STATE OF VERMONT
AGENCY OF TRANSPORTATION

RECORD PLANS	
CONTRACTOR:	ALPINE CONSTRUCTION, LLC - SCHUYLERVILLE, NY
RESIDENT ENGINEER:	RON LEMAIRE
CONSTRUCTION BEGAN:	MARCH 09, 2015
CONSTRUCTION COMPLETE:	JUNE 05, 2017
RECORD PLANS BY:	RON LEMAIRE & AARON WEAVER

PROPOSED IMPROVEMENT
BRIDGE PROJECT
TOWN OF BENNINGTON
COUNTY OF BENNINGTON
BENMONT AVE. (TH-7) (URBAN MINOR ARTERIAL)
BRIDGE NO. 57

PROJECT NAME : BENNINGTON
PROJECT NUMBER : BRF 1000 (16)

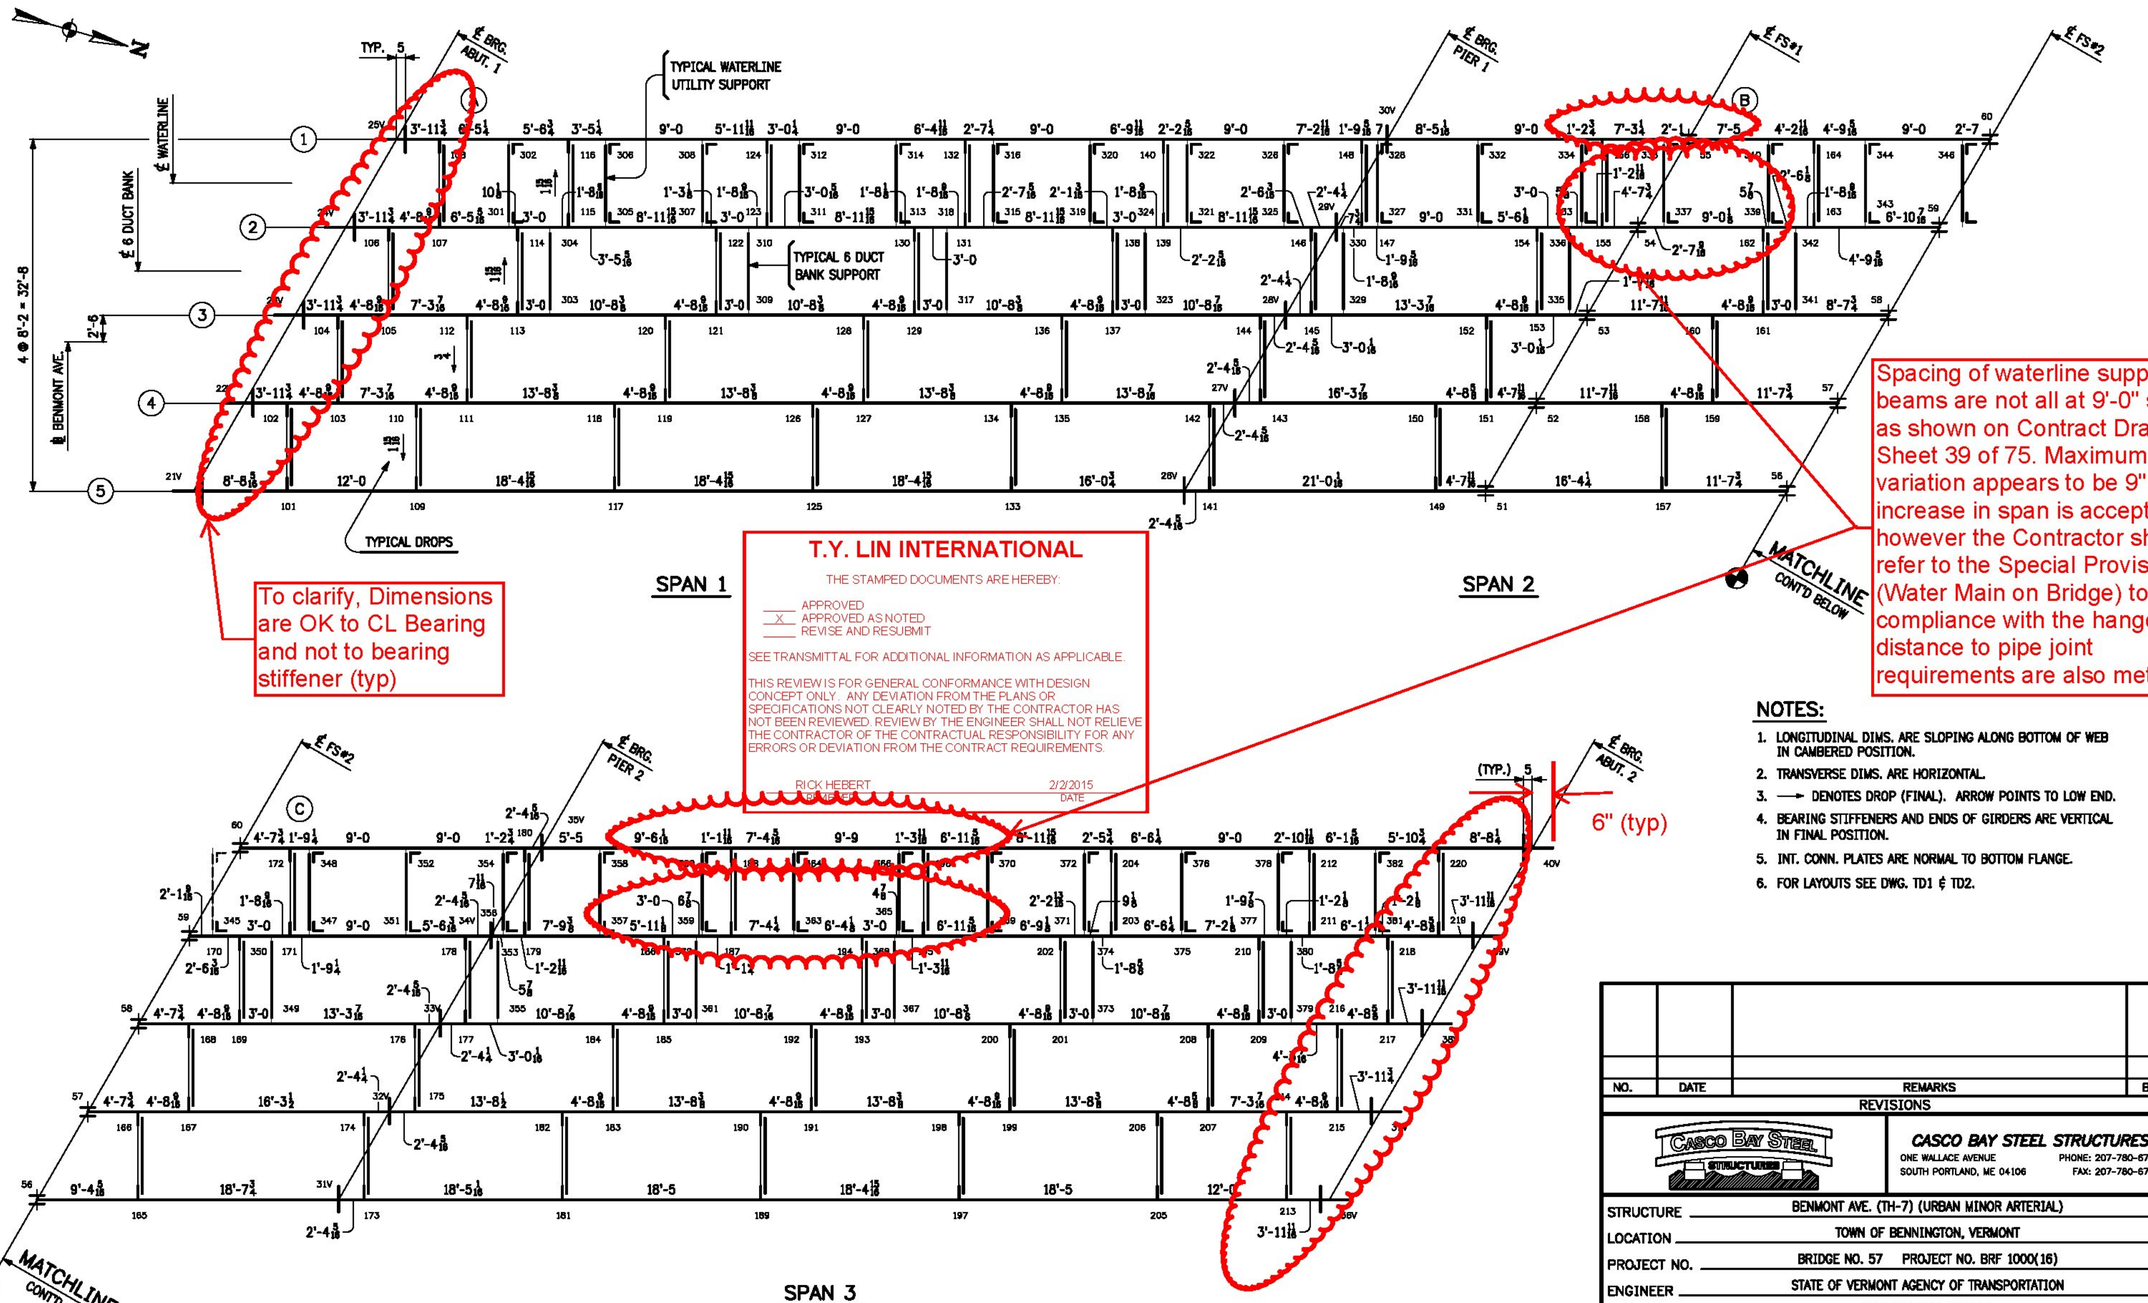
To clarify, Dimensions are OK to CL Bearing and not to bearing stiffener (typ)

Spacing of waterline support beams are not all at 9'-0" spaces as shown on Contract Drawing Sheet 39 of 75. Maximum variation appears to be 9". The increase in span is acceptable, however the Contractor should refer to the Special Provision (Water Main on Bridge) to ensure compliance with the hanger distance to pipe joint requirements are also met.

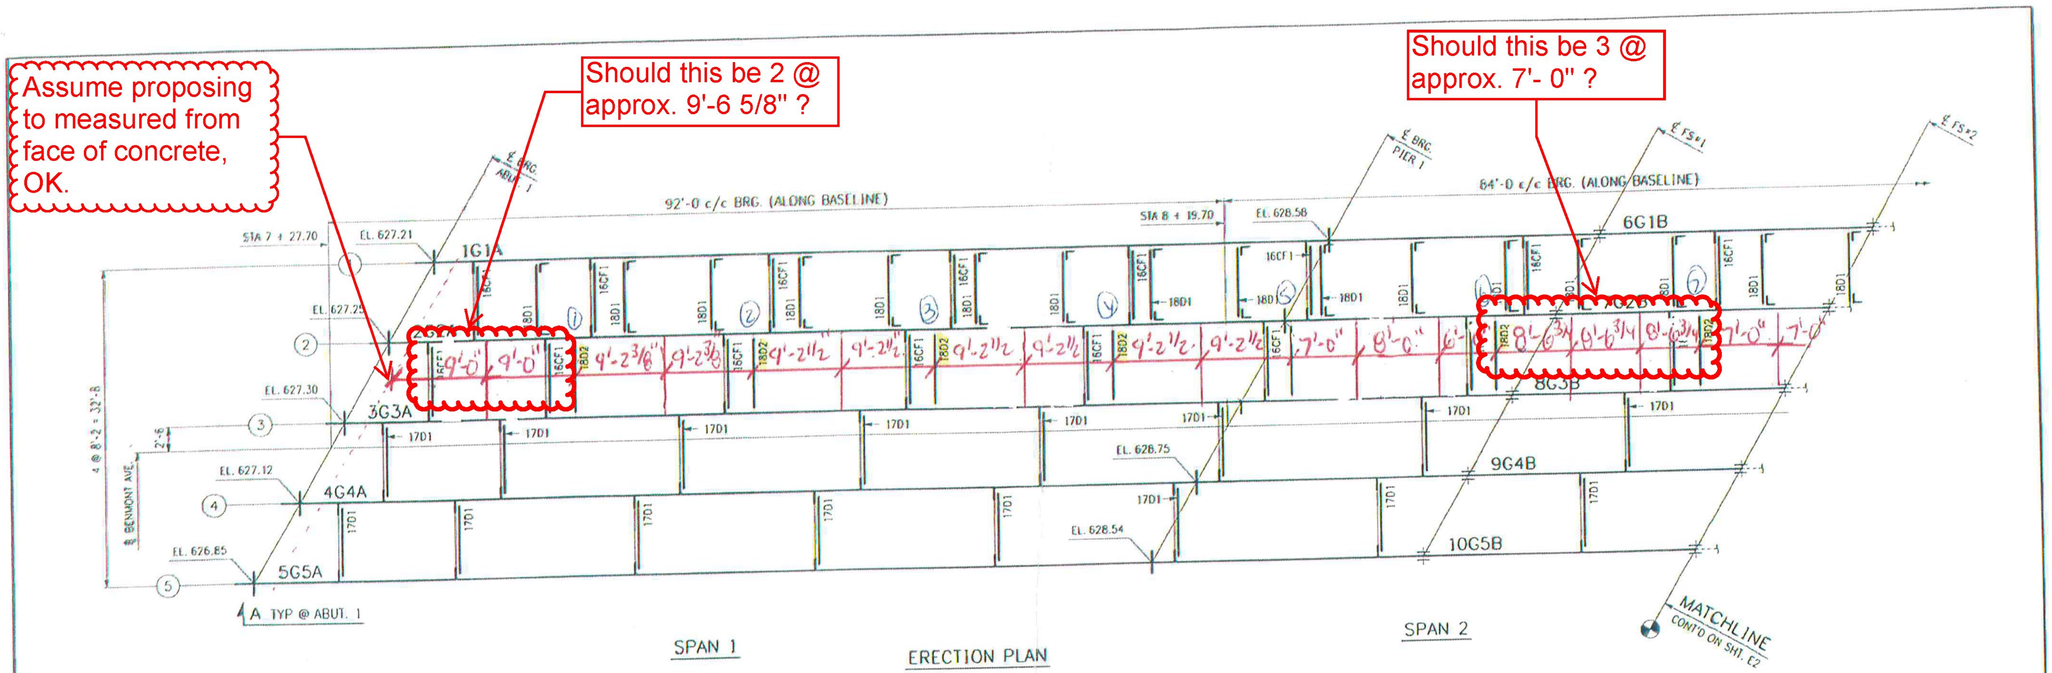
Should this be 3 @ approx. 7'- 0" ?

Ok with general spacings as indicated. Did find some minor discrepancies with summations for spacings in comparison to locations of utility supports shown in approved shop drawings. Just check/verify spacings as noted.

SPAN 3

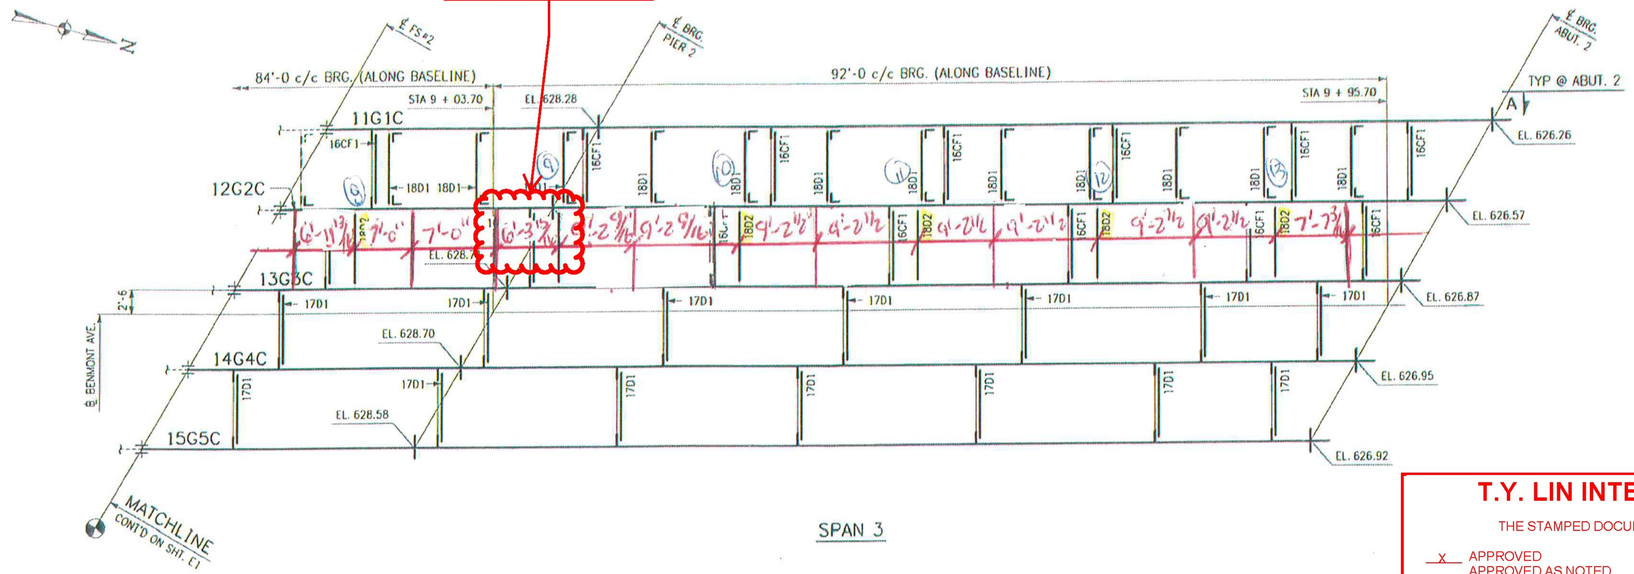
Should this be approx. 7'-0" ?
